SITE PLAN MODIFICATION 27 FORGE PARKWAY FRANKLIN, MASSACHUSETTS

RE: Site Plan Modification – #27 Forge Parkway, Thermo Fisher Scientific

Site Plan Modification and Limited Site Plan

SITE MAP

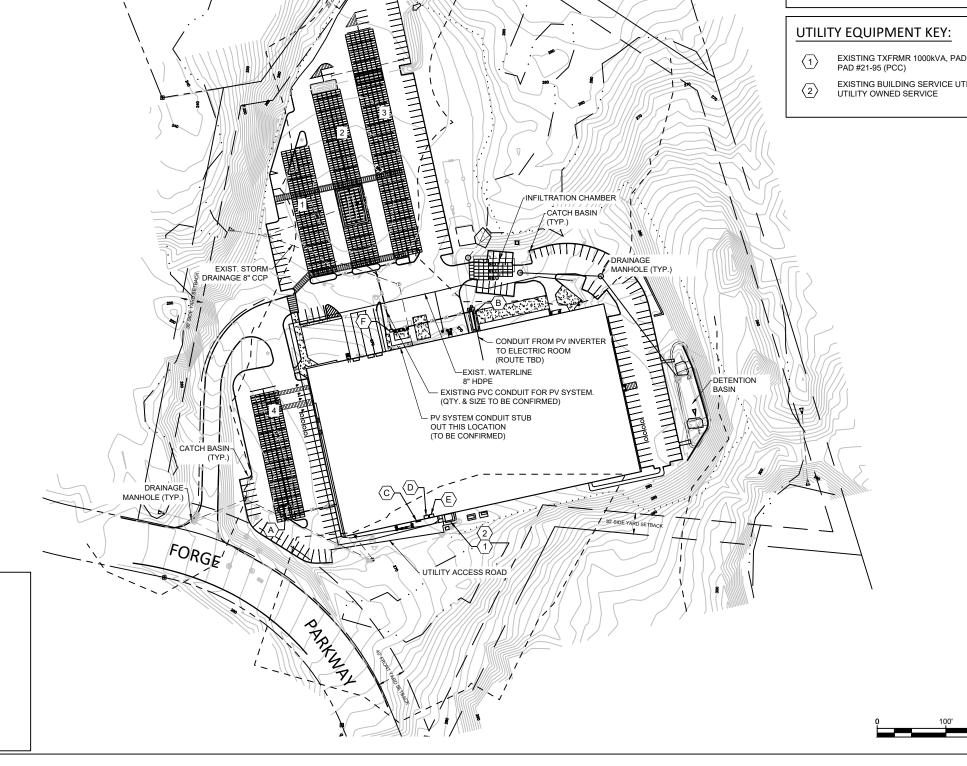
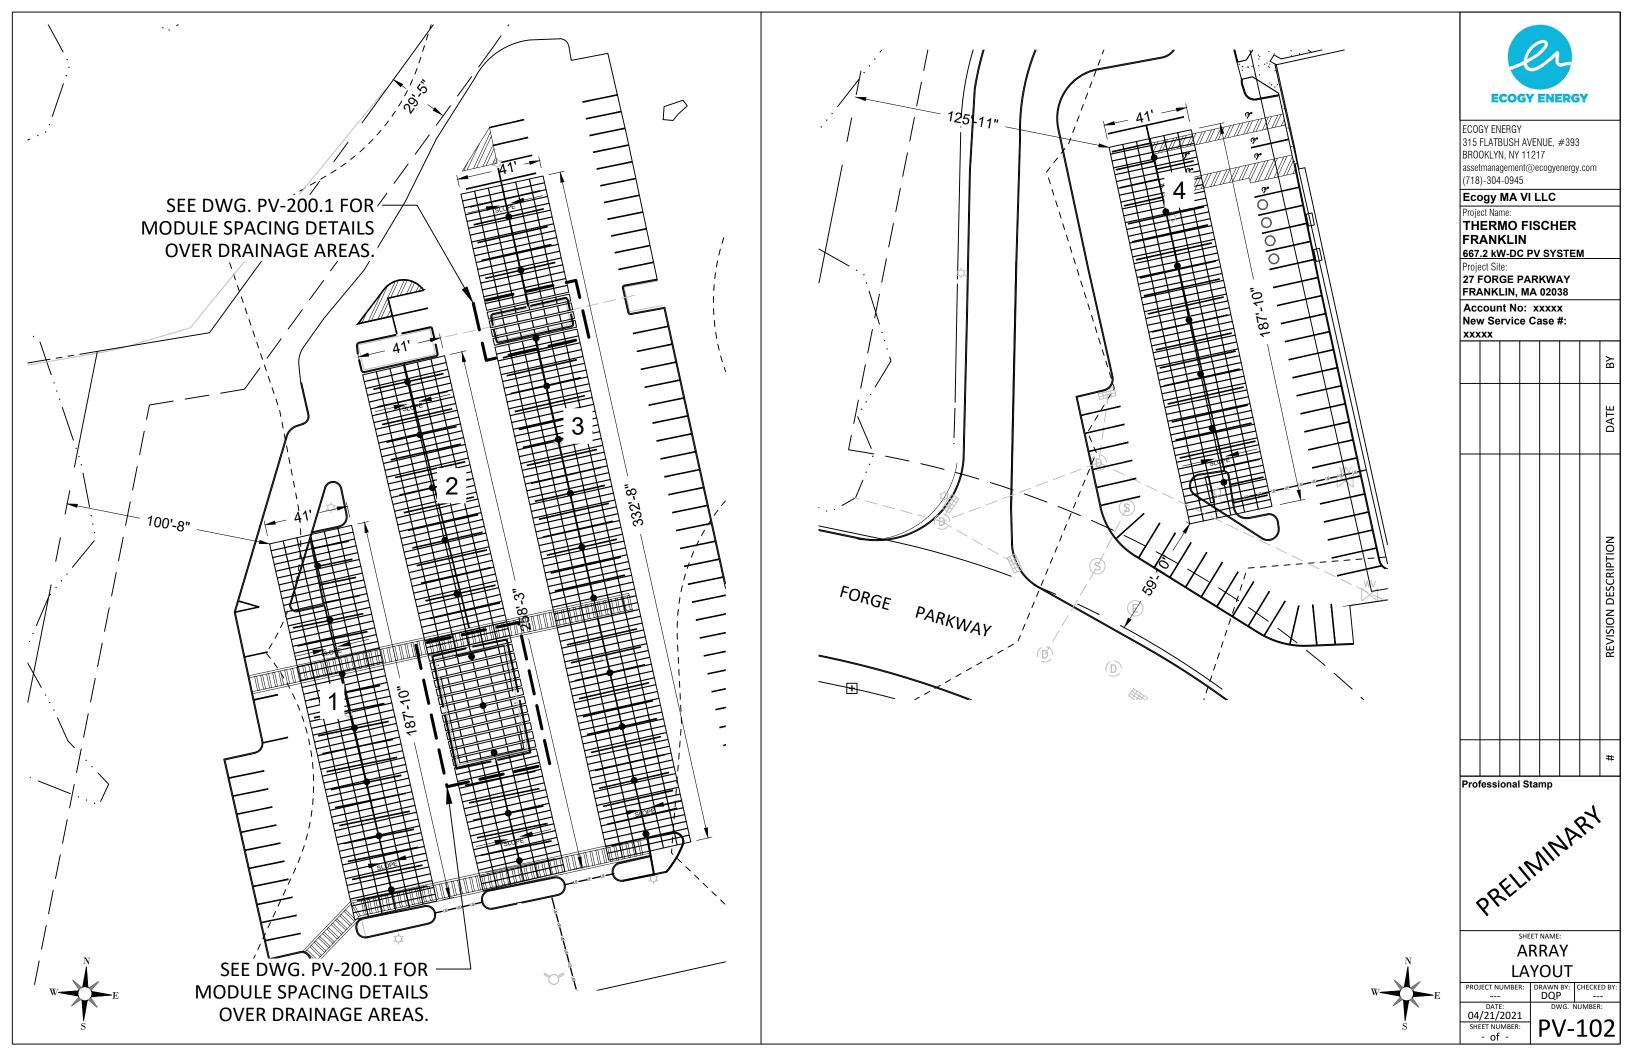
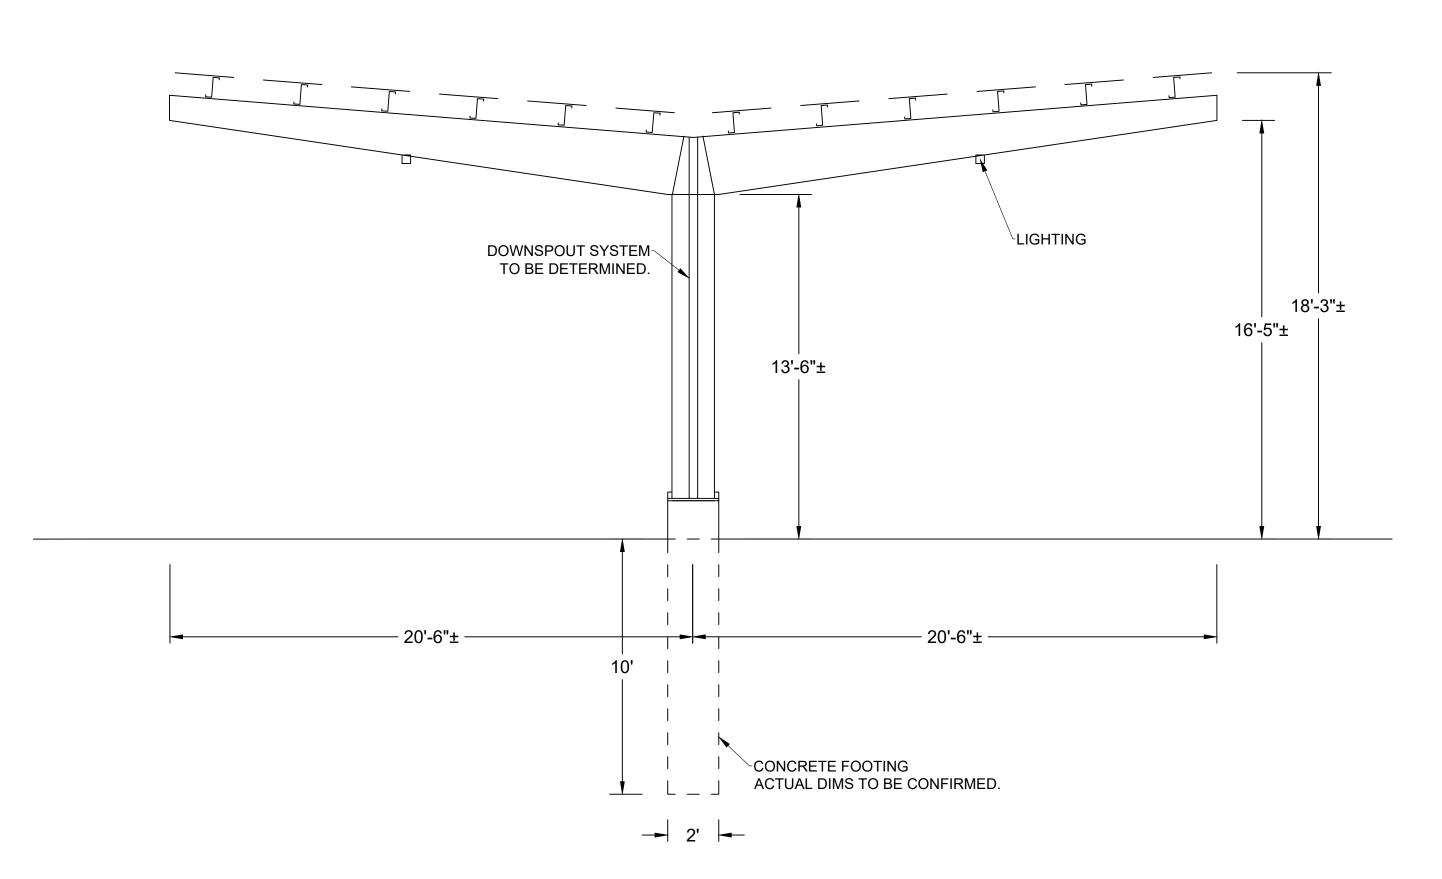
- 1. The updated plans show 12" spacing between solar panels over the existing bioretention areas. As previously noted, we still recommend that the solar canopies be positioned so as to skip over the bioretention areas completely so that they may continue to be exposed to full sun.
- 2. We also note that detail for the canopy shows a downspout system that is "to be determined." Currently, the storm water runoff from the pavement is directed to the existing bioretention areas. It is unclear how the downspout system associated with proposed solar panels will affect the current drainage.
- 3. The previously noted parking lot island relocations are not shown on the current plan.
